Re: Supplemental Submission

April 13, 2020 Public Hearing – Applicants’ Response to Comments – DEP File No. 301-1287
Sudbury-Hudson Transmission Reliability and Massachusetts Central Rail Trail Project

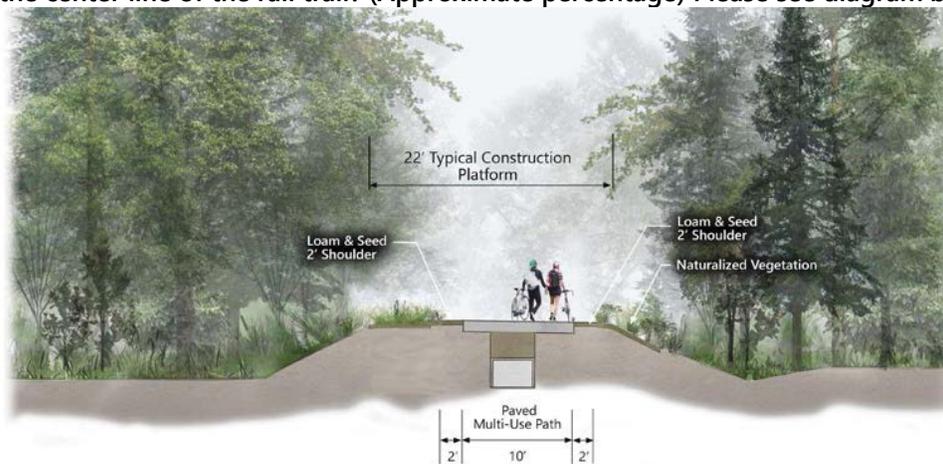
73. Question for Eversource. How much of the transmission line has been designed to be located under the center line of the rail trail? (Approximate percentage) Please see diagram below.
